**Draft Corrigendum to Regulation No. 58, 02 series of amendments
(Rear underrun protection)**

A. PROPOSAL

1. Scope of the Same Type

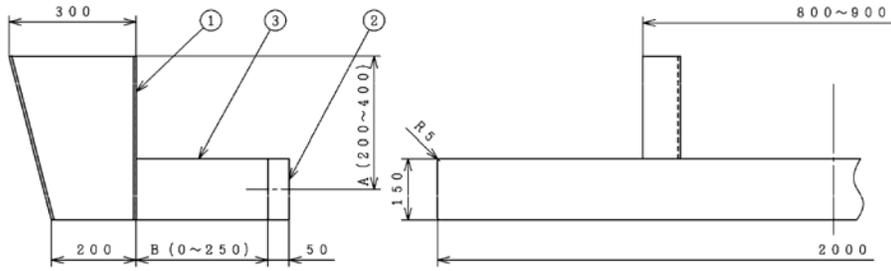
Paragraph 4.1.2., correct to read:

"4.1.2. "Type of RUPD" means RUPDs which do not differ with respect to the essential characteristics such as shape, dimensions, attachment, materials and the markings cited in paragraph 5.2.2 below.

And, RUPDs which do not differ with respect to the essential characteristics means those RUPDs having the same design characteristics with respect to shape, dimensions, attachment, materials and the markings and whose deformation levels, as measured pursuant to Annex 5, are deemed to be equal to or lower than the approved type. "

In Japan, when testing the RUPD components according to Annex 5 for type approvals, the basic shapes of stays and bars must be the same. In cases where there are differences in the length, etc., a table showing various combinations of the differentiated dimensions based on the basic shapes is submitted and the performance test is conducted using the combination that will cause the worst deformation when test force is applied. If this test is passed, it means that that the RUPDs shown in the table on various combinations do not differ with respect to the essential characteristics. This should be stated clearly in the provision.
